02 - 2015
DUB362Z
18Vx2 (36V) Brushless Blower

SERVICE CHANGES

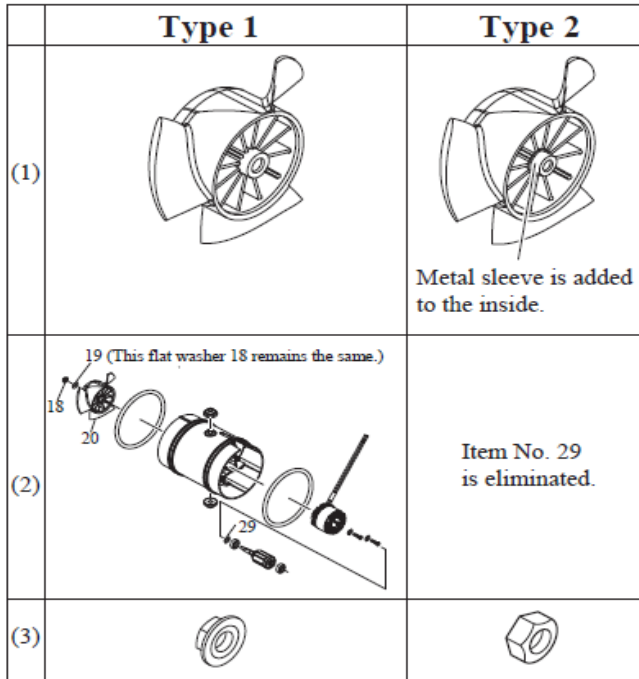
1. Changes on Fan and M5 Corned disc spring hex nut, Elimination of Flat washer 8

Item No.	Description	Type 1	Type 2	Type 3	Figure
18	CORNED DISK SPRING HEX.NUT M5 >>>HEX LOCK NUT M5-8	264111-7	252103-8	252286-4	(3)
20	FAN 110	240158-5	240177-1		(1)
29	FLAT WASHER 8 (OLD TYPE)	253835-0	-----	-----	(2)
19	F:AT WASJER 5	253194-2		-----

Item no. 20 & 29 are completely interchangeable as a set.

Item no. 18 & 19 are completely interchangeable as a set.
